**COUNTY OF SAN MATEO  
PLANNING AND BUILDING DEPARTMENT**

**SUBJECT:** EXECUTIVE SUMMARY: Public hearing to consider an appeal of the Coastside Design Review Committee's decision to approve a Design Review Permit for the construction of a new 2,132 sq. ft. two-story single-family residence, plus a 474 sq. ft. attached two-car garage on an existing 5,000 sq. ft. legal parcel in the unincorporated Montara area of San Mateo County. No trees are proposed for removal.

County File Number: PLN 2015-00011 (Segner/Lai)

2  
A4.1  
NORTH  
ELEVATION (LEFT)

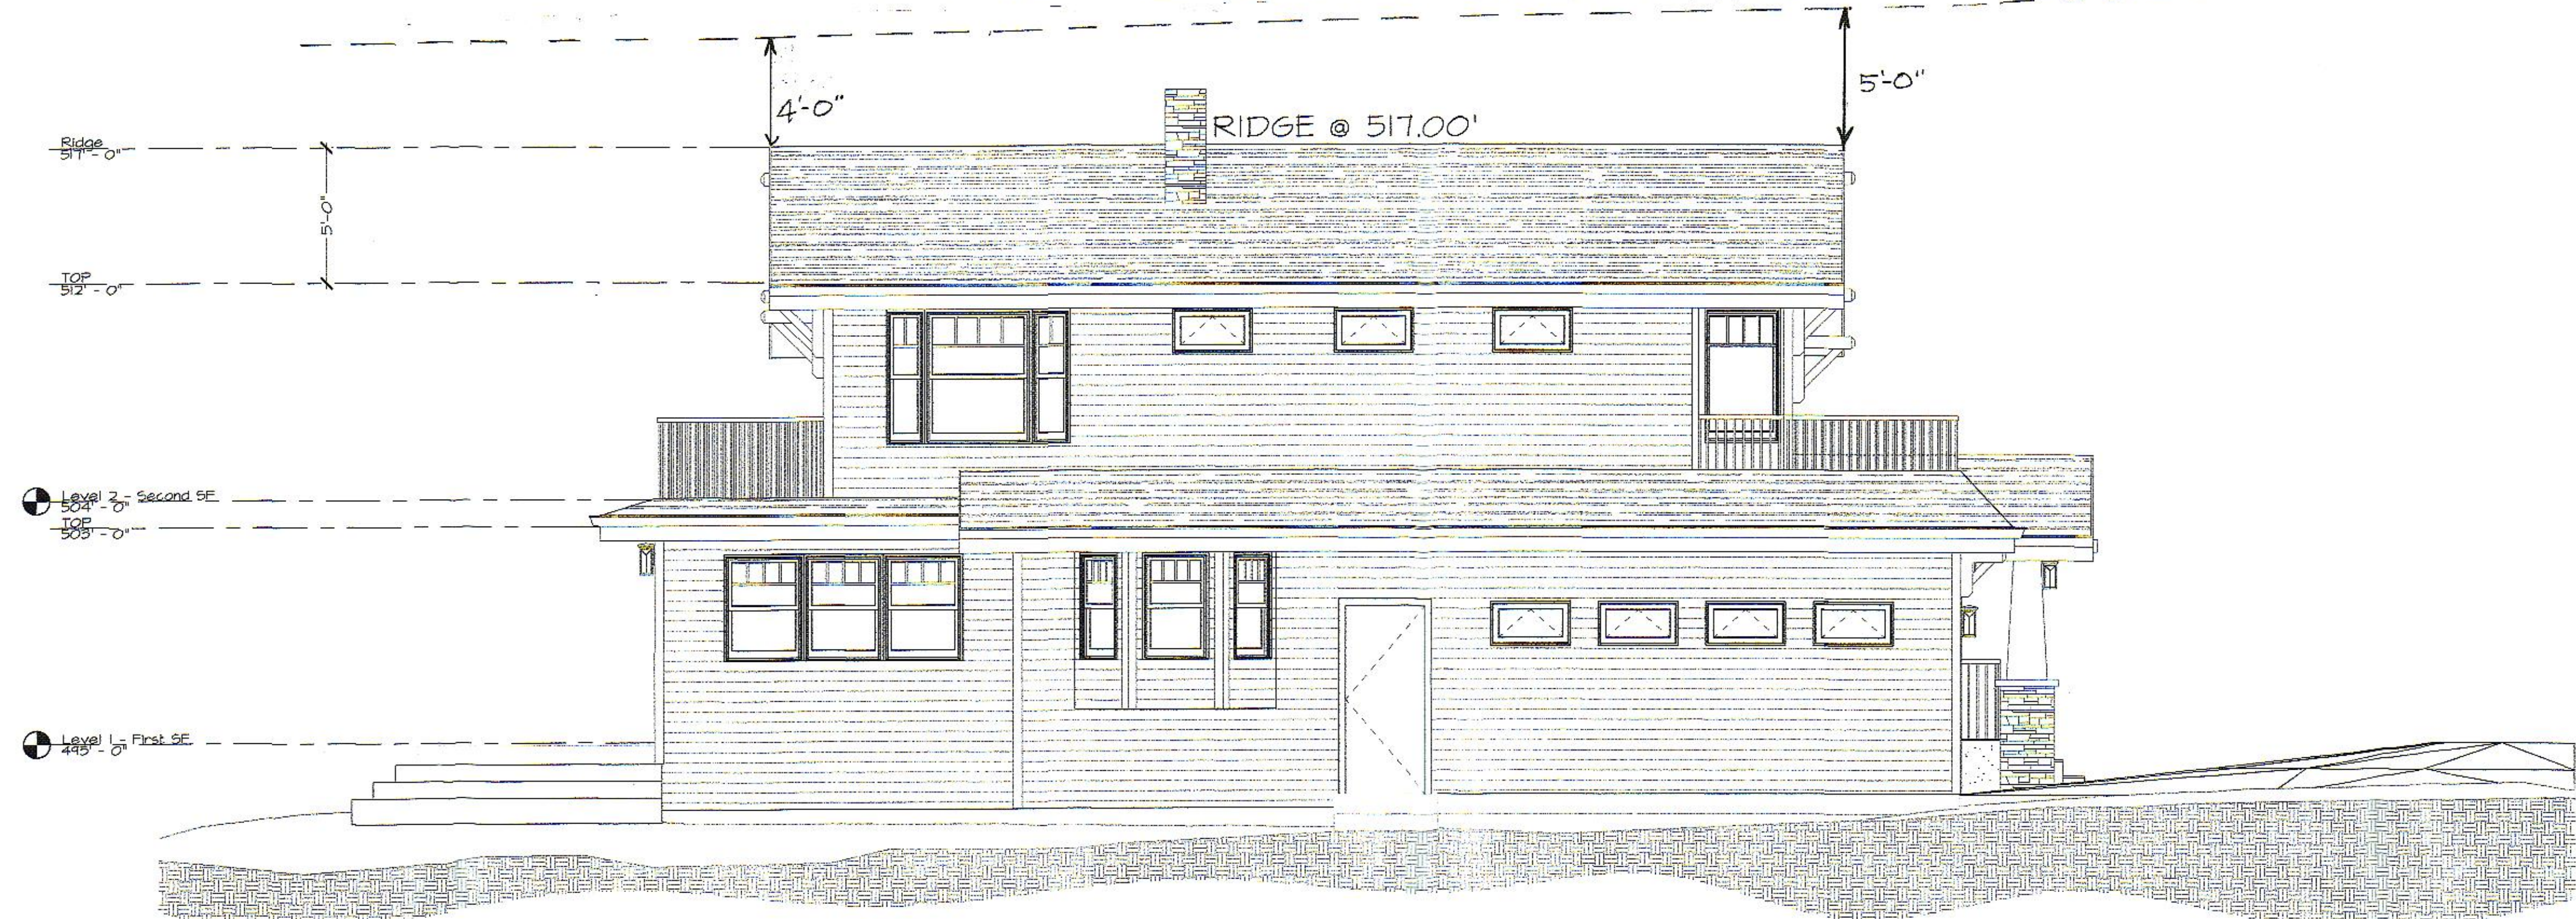
1. Appellant: The Applicants have placed two (2) oversized windows on the North Elevation of the house which compromise the Appellant's privacy, particularly for use of his rear deck. On both floors, continuous sets of windows are, in total, approximately 8 to 9 feet wide. He requests that the Applicants split the sets of windows on both levels, which would still provide the Applicants adequate natural light and views.

- The applicant is basing his plans on the South, or higher elevation side, of the property. The result is that in addition the 3 foot retaining wall; the applicant’s back deck (See North Elevation (Left)) will also be approximately 3 feet above the grade on the North side of this construction. That is a total of 6 feet above the elevation of my property and back yard. Therefore I am again left with privacy concerns because the height of this back deck will be significantly higher relative to my yard, decks and property.

Staff's Response No. 1: As directed by the CDRC at its October 22, 2015 meeting, the Applicants have reduced the span of the second floor set of windows to no more than 10 feet, proposing a total span of 7 feet. The width of the first floor set of windows have been reduced to 9 feet. In approving the project, the CDRC found that the window placement and size of the second floor windows mitigate privacy impacts to the adjacent neighbor by limiting the total width to 9 feet and placing one of the windows at a 45-degree angle westward.

After the filing of the appeal, the Project Planner worked with the Applicants and the Appellant on major points of the appeal to see whether design changes that are agreeable to both parties could be made. The Applicants have submitted revised plans (Attachment D) to address this concern. In a phone conversation with the Appellant on August 23, 2016, the Appellant stated that the revised plan addresses his concerns regarding the window.

GRADING PLAN

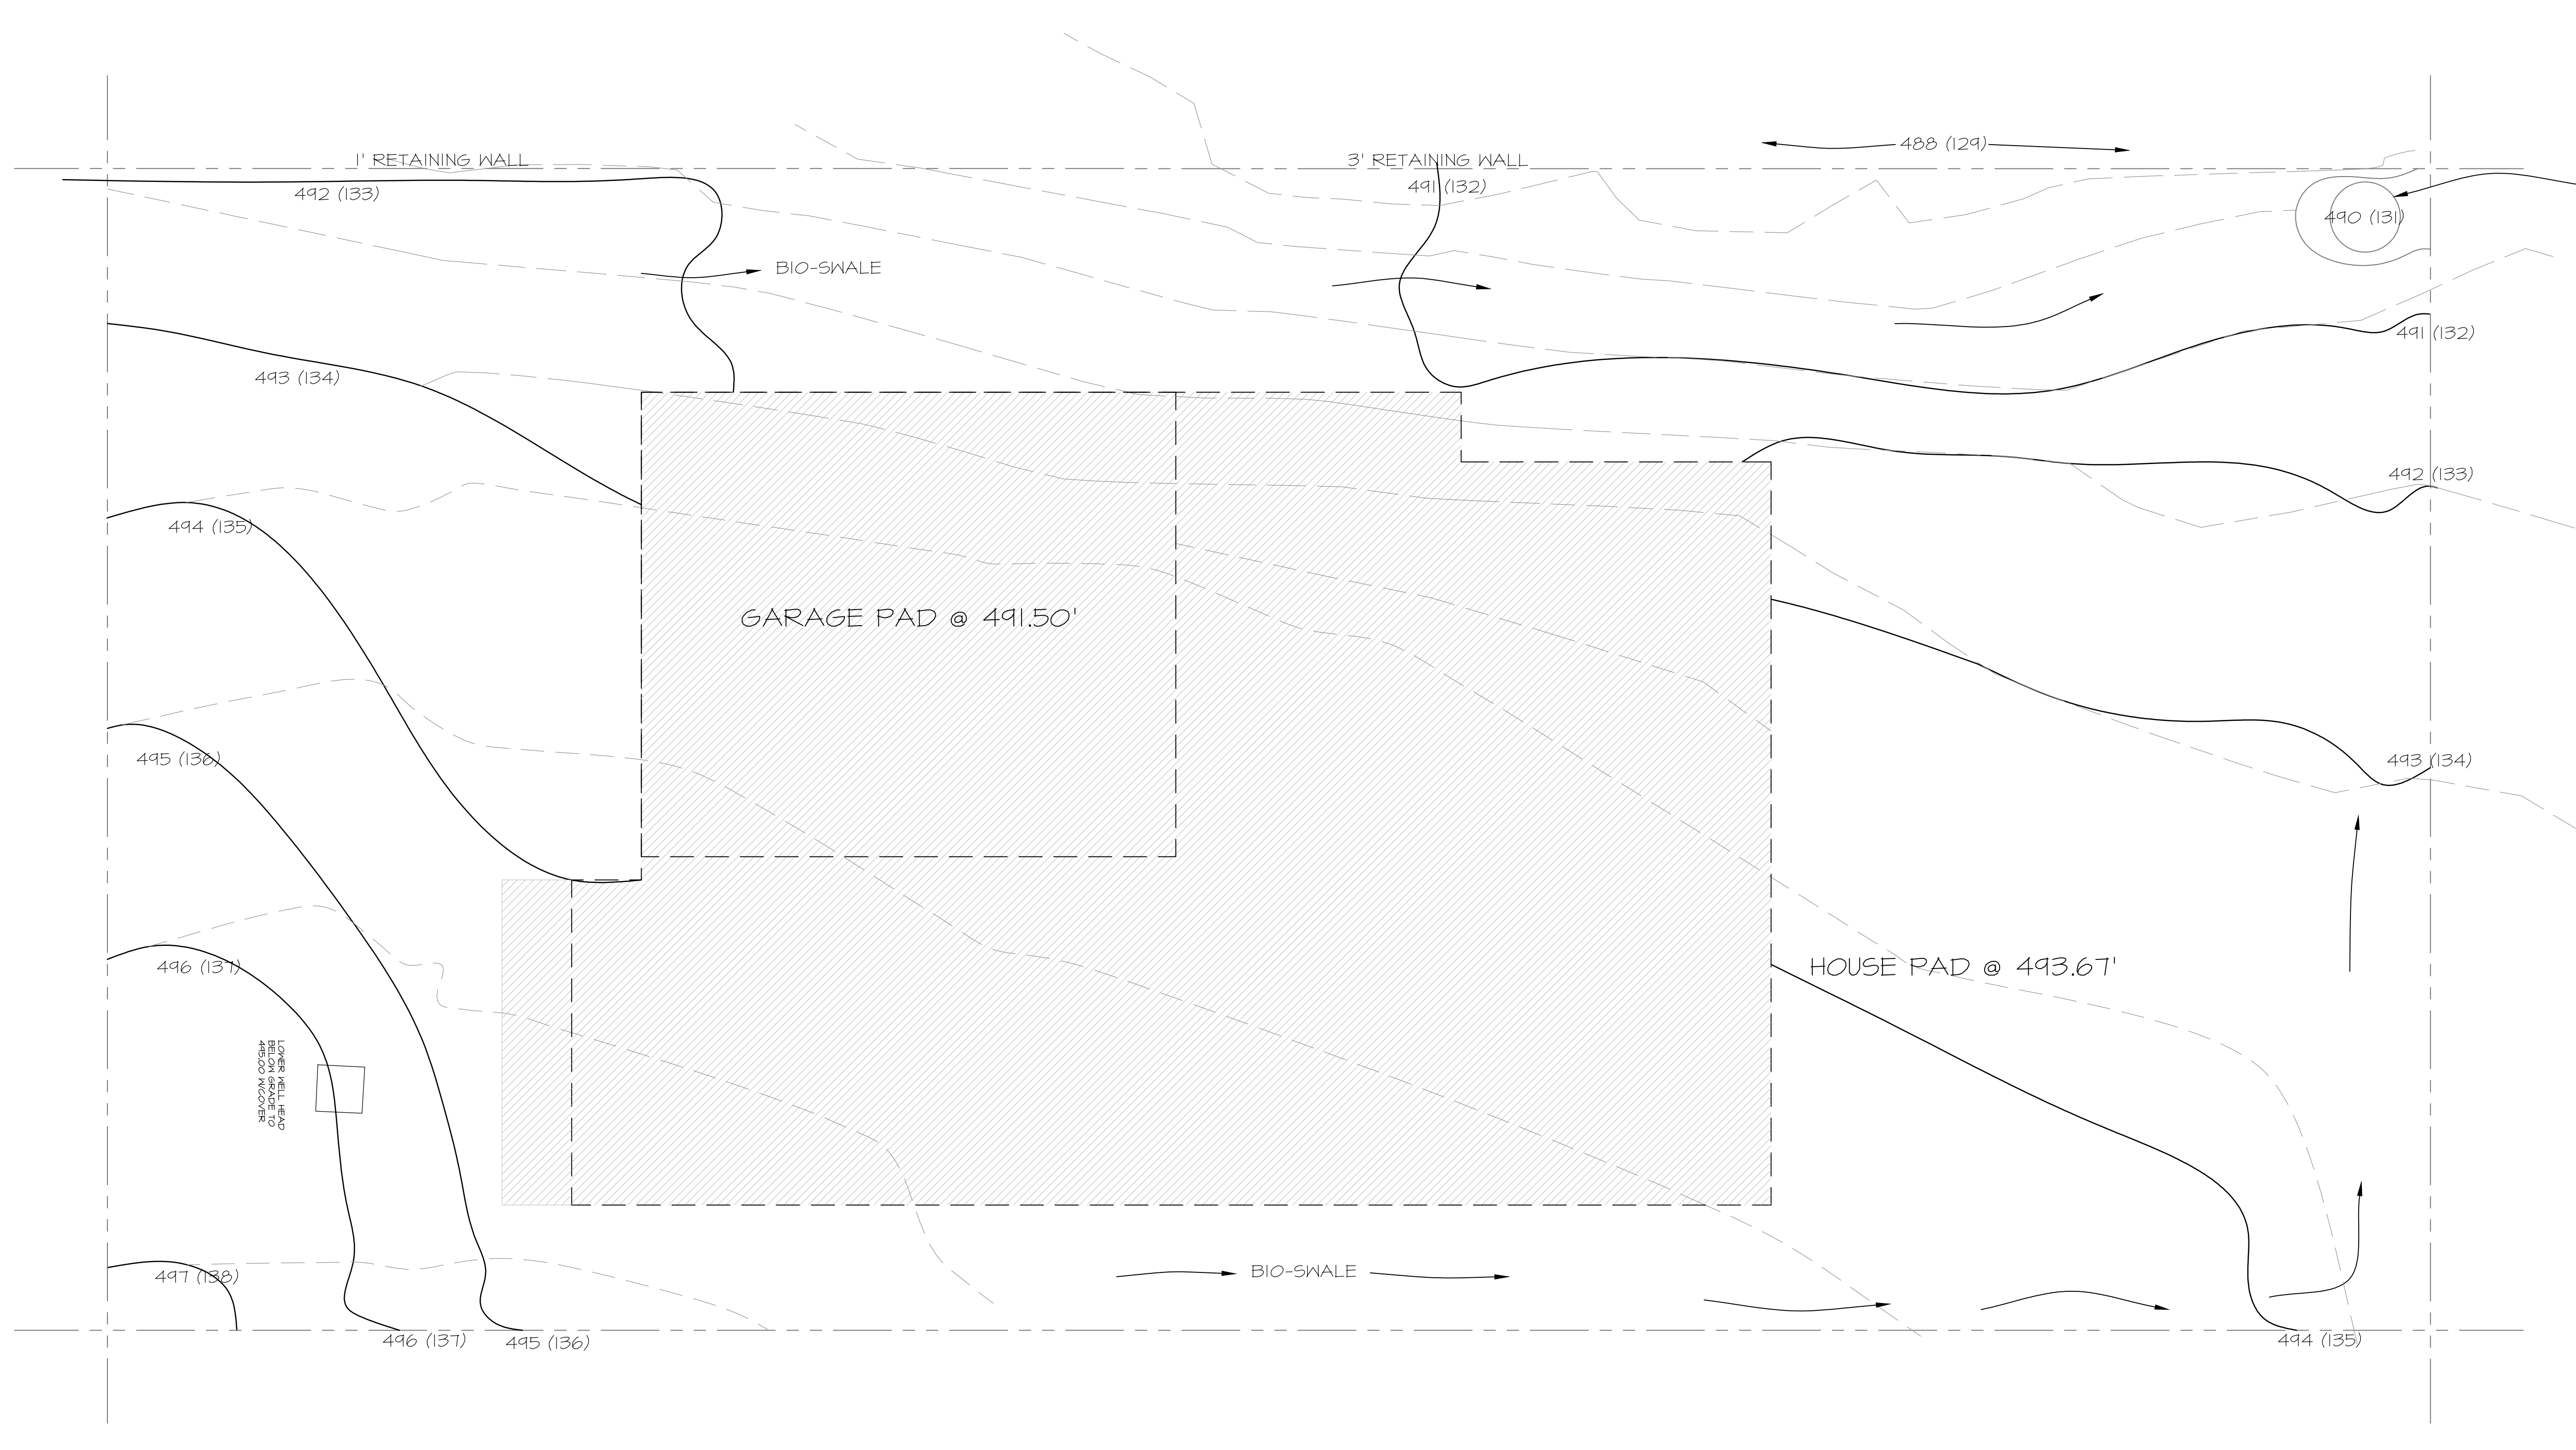
In the Appeal Application (Attachment E), the Appellant requested the Applicants to lower the building pad by 6 feet (to 489 feet). This would alter the existing topography and significantly increase grading to approximately 355 c.y., requiring a Grading Permit. As shown in the revised plans, the Applicants have lowered the elevation of the house by 2 feet, from 495 feet to 493 feet, to match the proposed elevation of the garage. In a phone conversation with Planning staff on August 23, 2016, the Appellant stated that the house should be lowered a minimum of 4-5 feet from the CDRC-approved floor elevations and that the subsequent lowering of the house by 2 feet was not adequate to his concerns. The Applicants have stated that due to increased costs associated with additional grading, they do not agree to further lower the elevation of the house from the elevations shown in the revised plans.
